MORPHE
#029
THE FLORIDA
MALL
8001 SOUTH ORANGE
BOSSUM TRAIL
SUITE #410B
ORLANDO, FL 32809

STOREFRONT ELEVATION, ENLARGED PLAN AND DETAILS

A200

1 STOREFRONT ELEVATION
A200 SCALE: 1/2" = 1'-0"

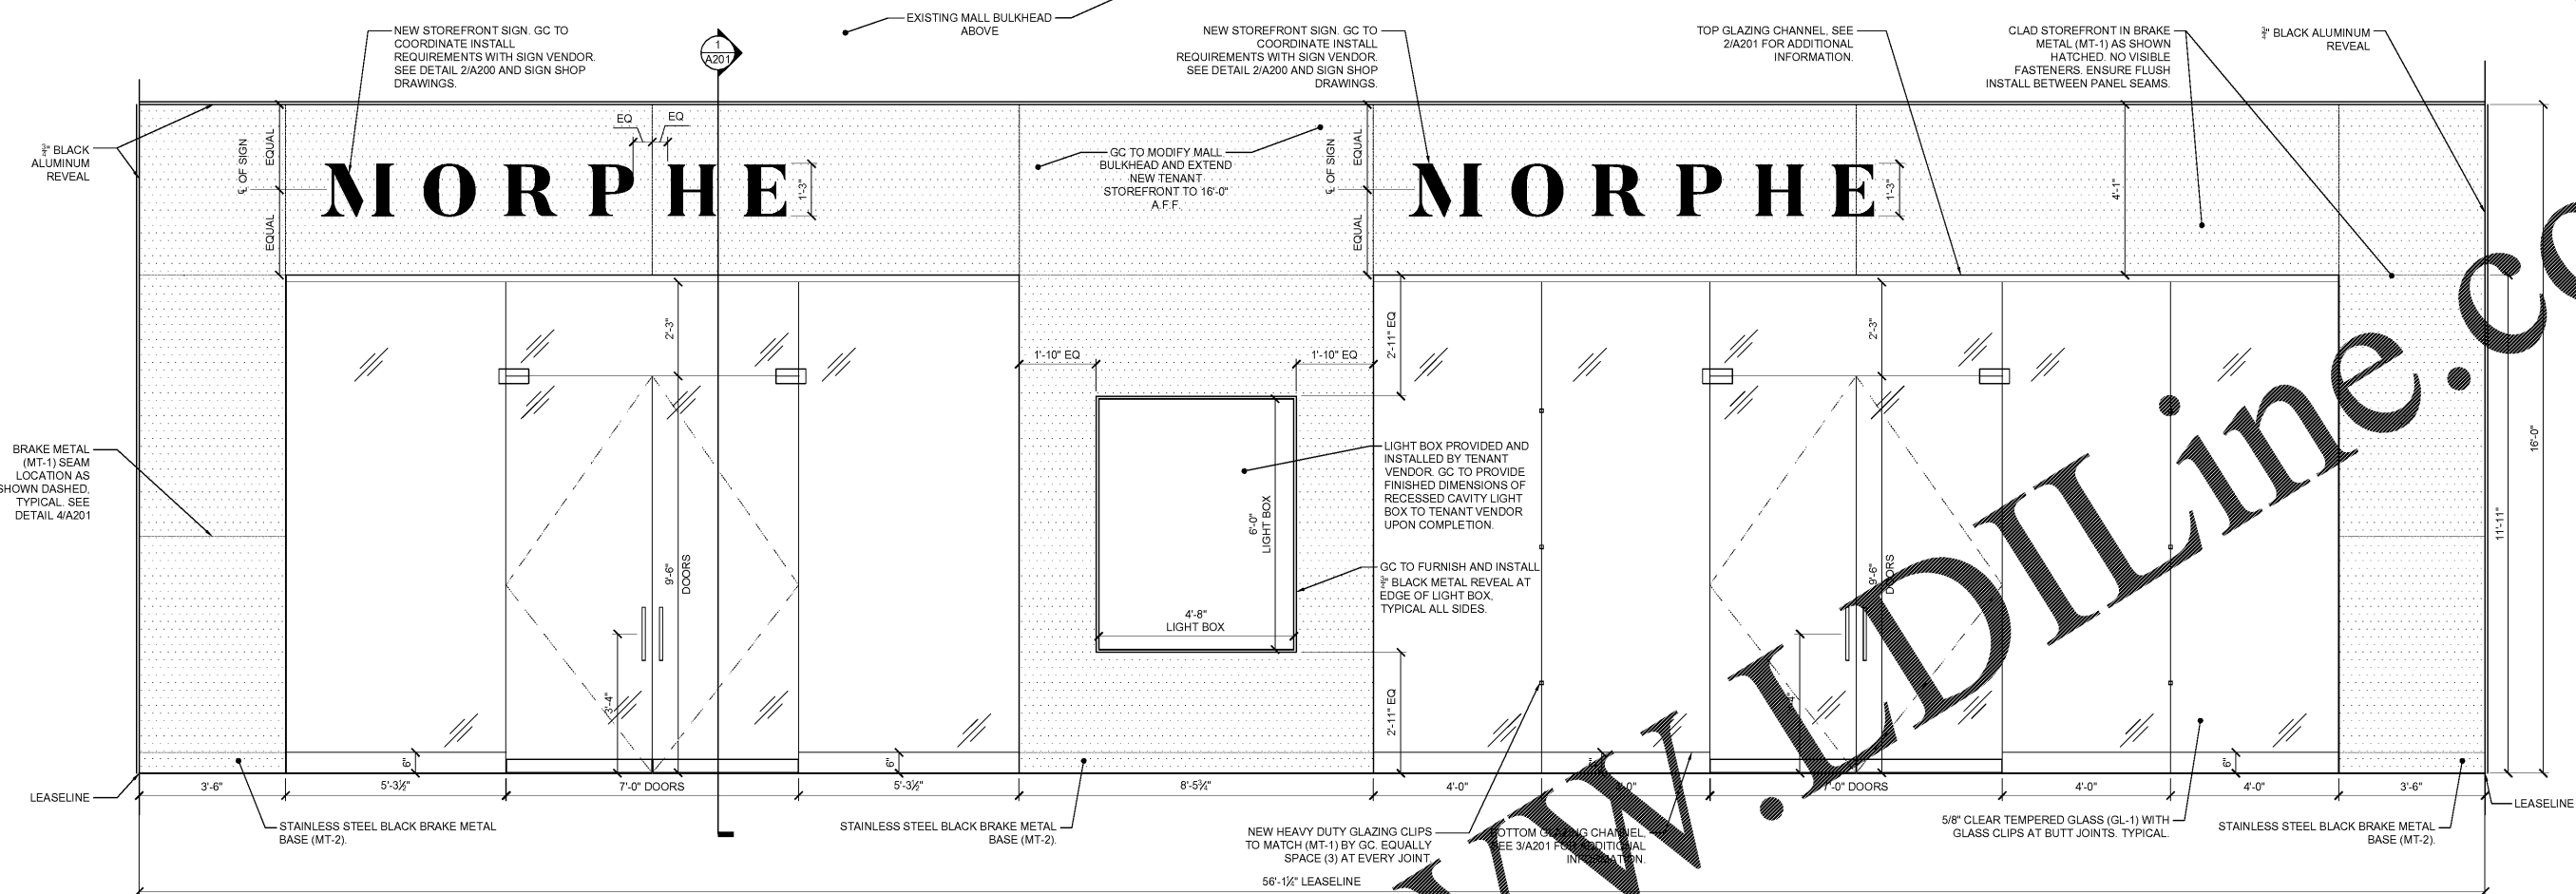
Storefront Elevation / Section Comments:

- If not already existing, tenant must provide a sealed partition above the storefront to separate the Common Area ceiling from the tenant's space. (Should be noted if required by code and all penetrations shall comply and be labeled with the required NFPA rating.)

- Nothing is permitted to be attached to, suspended from, or penetrate Landlord's structure, floor deck, or roof deck. You may attach, non-destructively, to or suspend from the top chord of the joint or the structure of steel which occurs above the tenant space. When attaching to Landlord's structure, do NOT drill, weld, screw, or shoot into structure. Alternative methods of attachment shall be nothing to damage Landlord's base building structure. Tenant shall provide signed and sealed structural drawings, by a structural engineer with legally active registration as indicated by all jurisdictional requirements, for all structural modifications for Landlord records.

- Any Landlord equipment, component, and / or service leading other tenants) that is existing in the space must remain visible and accessible to the Landlord. Tenant shall install access panels as required to maintain access. Access panels shall be label to properly identify system, coordinate with Mall Operations.

- When Storefront Drives are permitted by Landlord, they must be floor supported and shall attach to Landlord's structure for lateral support only. When in open position, bottom rail of grille must be fully recessed into ceiling treatment above. No welding to structure is permitted.

- Slat wall may not be used within the first 5'-0" of the space.
- Vertical glass joints shall be frameless butt joints.
- Painted drywall is not an acceptable storefront finish.

- Any damage to mall property or adjacent tenants during construction must be repaired to Mall specifications, at Tenant's expense.
- Storefront sign must be on a 7-day, 24-hour time clock. Illuminated signs must remain illuminated during all mall hours.

- Approval of the Tenant's Construction / Design Documents by the Landlord shall not constitute review and approval of the Tenant's Signage. Signage shop drawings must be submitted under separate submittal for Landlord review and approval prior to fabrication and installation of the sign.
